Planning, Zoning and Building Department

Project Name: Delray Medical Center
Project Location: 5352 Linton Blvd
Request: Class II Site Plan Modification
Board: Site Plan Review and Appearance Board
Meeting Date: May 10, 2017

ITEM: Delray Medical Center – Class II Site Plan Modification, Landscape Plan, and Architectural Elevations Associated with the previously approved Bed Towers and Parking Garage. (File 2017-137)

**DELRAY MEDICAL CENTER
BED TOWER EXPANSION
CLASS II SITE PLAN REVIEW
April 6, 2017**

**OVERALL HARDSCAPE
PLAN**

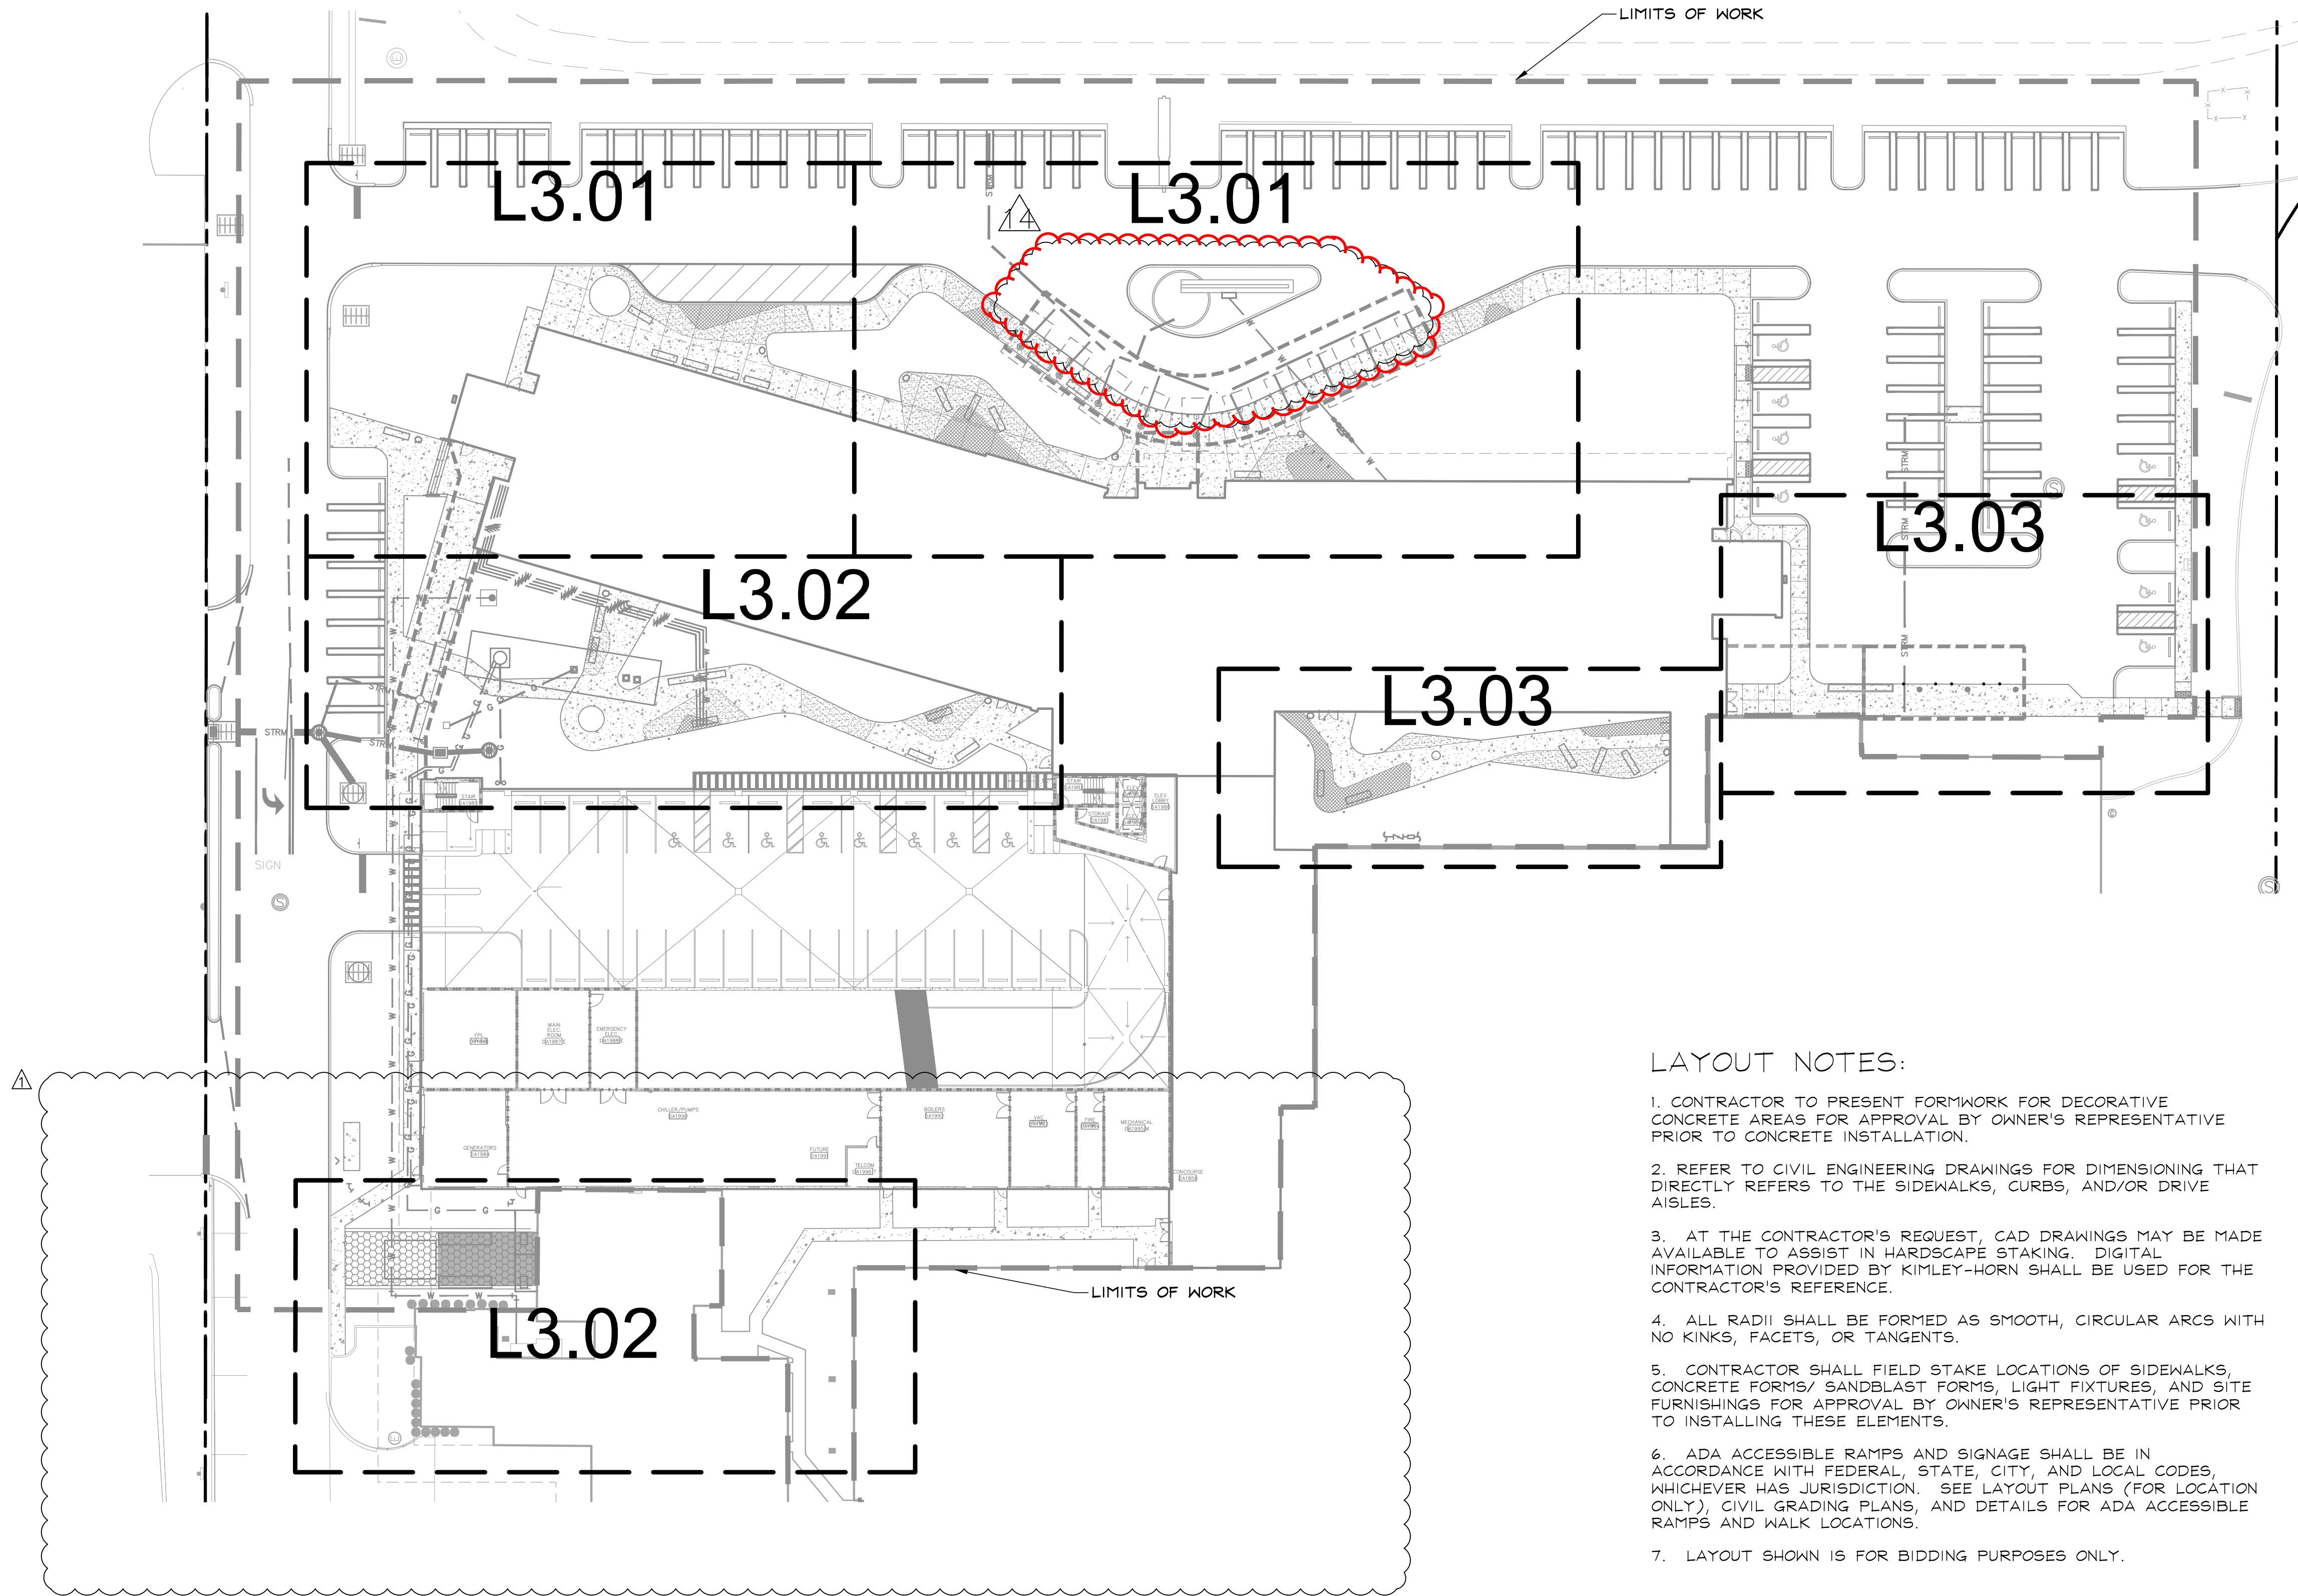
1. Amend plans to reflect asphalt pavement at the new Bed Tower drop-off drive. Plans previously called for decorative pavers. (*Engineering Plan C3.00, Hardscape Plan L3.00 and L3.01*)

5. Add an additional 5-foot of width to the existing 5-foot walk located on the west side of garage, as it extends south.
(*Site plan SP-1, Engineering Plan C3.00, Hardscape Plan L3.00 and L3.01*)

6. Add a new 8-foot sidewalk west of the Oxygen storage area, located south of the garage. Sidewalk to provide connection to the parking garage.
(*Site Plan SP-1, Engineering Plan C3.00, Hardscape Plan L3.00 and L3.01*)

7. Add a 14-foot wide loading zone west of the Oxygen storage area.
(*Site Plan SP-1, Engineering Plan C3.00, Hardscape Plan L3.00 and L3.01*)
8. Add sidewalk detail for proposed sidewalk showing a thickened edge for the condition that occurs where the decorative concrete walk meets the asphalt paved drop off area. (*Hardscape Plan L3.10*)
